IOGP S-700J, Supplementary Specification to API Standard 671 for Special-purpose Couplings, Second Edition, April 2024

ADDENDUM 1

SPECIFICATION IOGP S-700J

ADDENDUM 1 TO SECOND EDITION (APRIL 2024)

Figure L.1 — Coupling Direction of Rotation and Power Flow

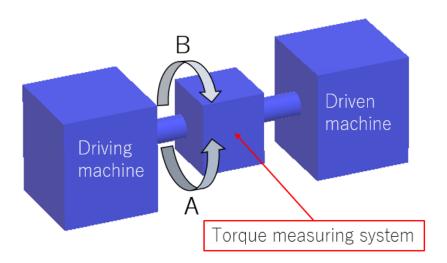
Add to list item e)

in accordance with Figure L.1

Add new Figure L.1

Figure L.1 provides a reference to allow the direction of rotation and power flow to be specified.

Figure L.1 provides a reference to allow the direction of rotation and power flow to be specified.
